United States Patent and Trademark Office

| APPLICATION NO. | FILING DATE | FIRST NAMED INVENTOR | ATTORNEY DOCKET NO. | CONFIRMATION NO. |
|-----------------|----------------------------|----------------------|---------------------|------------------|
| 10/632,350 | 07/31/2003 | Hiroshi Moriya | 16869N-085900US | 3966 |

DATE MAILED: 12/27/2004

DETAILED ACTION

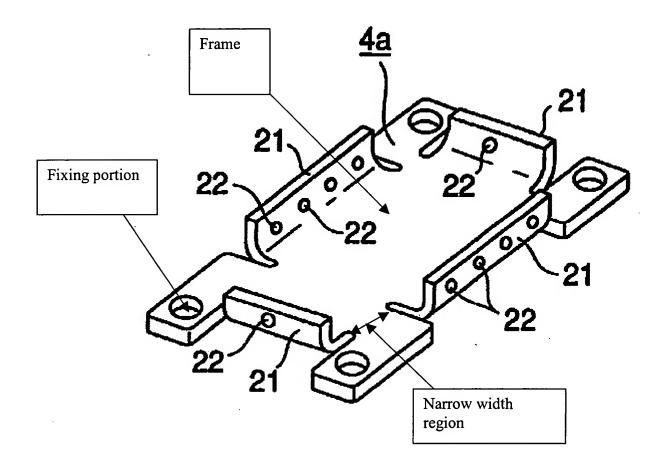
Claim 1 is rejected under 35 U. S. C. § 102 (e) as being anticipated by Kimura et al., U.S. patent No. 6,697,399.

Claim 1, Kimura et al. disclose a semiconductor laser module, comprising: a semiconductor laser element (2); a frame for storing said semiconductor laser element therein; an optical fiber (3) fixing portion being connected to said frame; a flange being connected to said frame, and having a fixing portion for fixing said frame on a substrate, wherein said flange has a narrow width region between a fixing region, including a fixing portion with said substrate therein, and said frame, and said narrow width region is narrower than width of said fixing region (See figure below).
